**ZONING BOARD OF APPEALS
MEETING AGENDA**

APPEAL #15.01

Dimensional Variance filed by Chicago Diversified Foods (Taco Bell), 15955 W Michigan Avenue, from:

CASE #15.01
STAFF REPORT

1 SITE PLAN
SCALE: 1" = 20'-0"

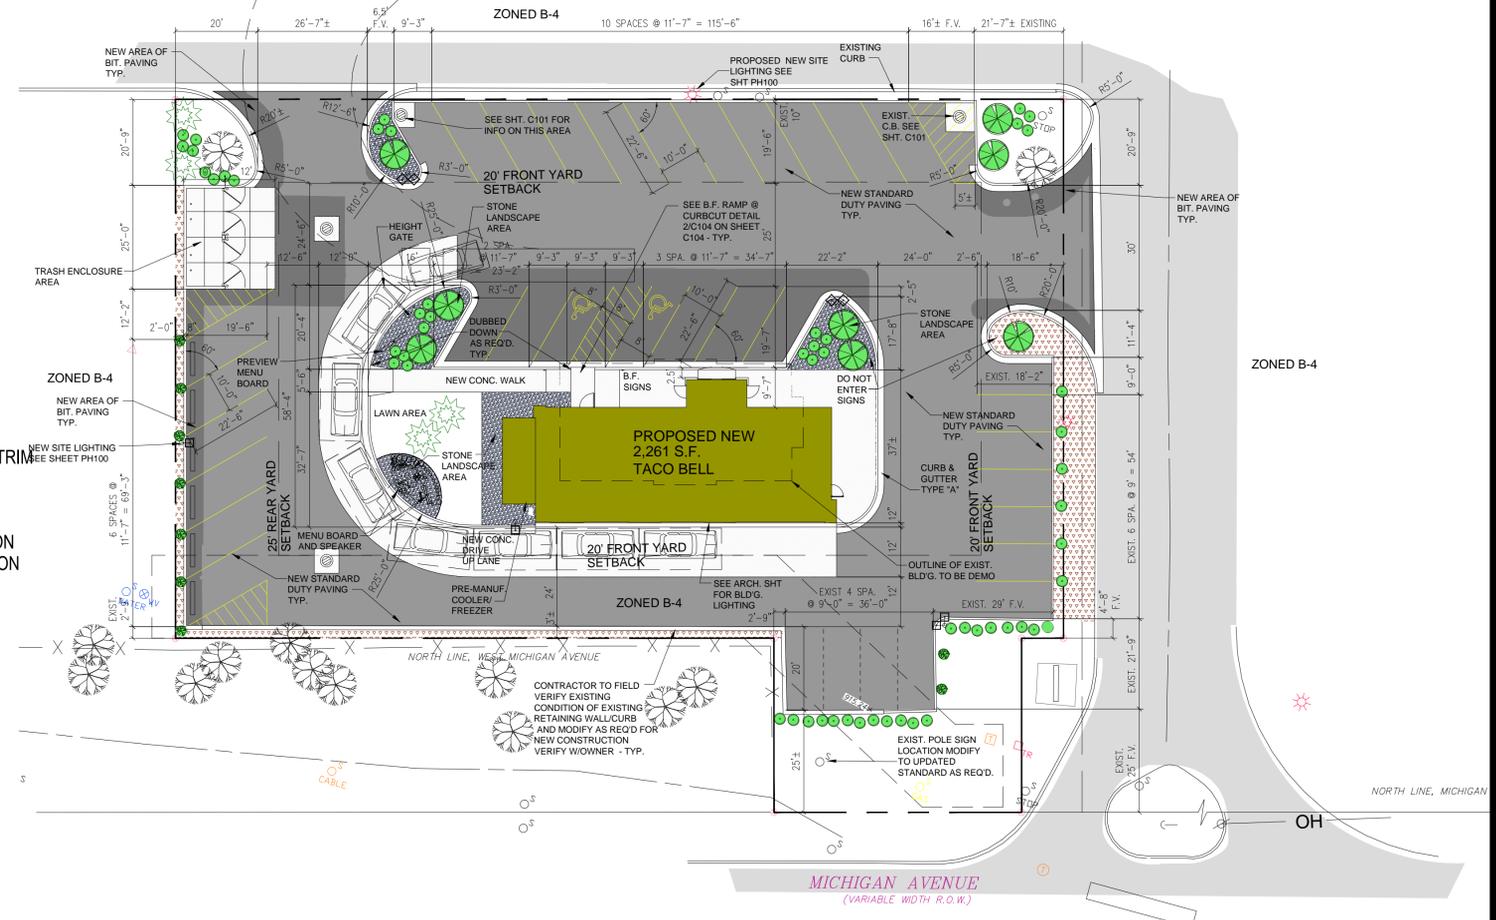
For this particular development, 25 spaces would be allowed, with a 20% increase, making the total allowable spaces 30 spaces. **They are requesting an increase of 5 spaces for a total of 35 parking spaces.**

The applicant has proposed a 2' setback to the west, 2' to the east, and 0' at the north boundary. While the boundaries in question do not abut a street right of way or any of the uses listed in the ordinance in order to enforce this requirement, the purpose of this requirement contributes to the ability to meet multiple other ordinances including barrier, landscaping, and screening obligations. Landscaping and screening requirements are addressed in the same variance application, but barrier requirements for the district are not and should be kept in mind.

The loading space is currently placed in a front yard, as well as overlapping with drive-thru stacking spaces.

While there is landscaping proposed for the site, the applicant does not meet landscaping requirements as set forth in the zoning ordinance. Items specifically not in conformance are parking lot screening from adjacent properties, lack of living groundcover, and the amount of landscaping in regards to the lot and parking area.

Staff Comment: (A) The need for an increase in parking spaces has not been substantiated by the applicant other than stating that the prototype building is specifically designed to have 35 parking spaces. (B) Parking lot setback requirements will decrease the buildable area on an already small parcel, but the lack of setbacks will increase the need for screening and other landscaping variances. (C) With 3 of the 4 boundaries being classified as a front yard and the last being a side yard, it is impossible to build a structure that requires any loading space without a variance in conformance with the ordinance. (D) Without perimeter screening of the parking area, headlights will be directed onto neighboring properties and into roadways which could create visibility issues. Interior and parking lot landscaping requirement could possibly be met by replacing evergreens with required deciduous and ornamental, replace excessive shrubs with the required trees, and replacing proposed river rock with grass or other living groundcover.

Staff Comment: Approval of requested variances will eliminate redevelopment requirements for this challenging property, but lesser variances should be considered for screening and landscaping requirements in order to protect neighboring properties' interests. Increasing the parking allowance by 5 spaces and allowing front yard loading area may create a hardship by completely denying the ability to improve the site.

Staff Comment: While most sites have a front yard, 2 side yards, and a rear, this site has three boundaries classified at front yards. Front yards carry much heavier restrictions in the ordinance compared to rear or even side yards. No matter which zoning district, three front yards create a unique and challenging situation. This lot is also very small in comparison to parcels with similar zoning. The average lot site in the B-4 district is 1.14 acres, while this lot is only 0.7 acres. The limitation of space creates a challenge to meet ordinance requirements that other B-4 properties can easily adhere.

Staff Comment: While the variances for landscaping, the loading area, and setbacks are not likely to create nuisances or have adverse impacts on adjacent properties, the lack of screening between the off-street parking and roadways could create a hazard.
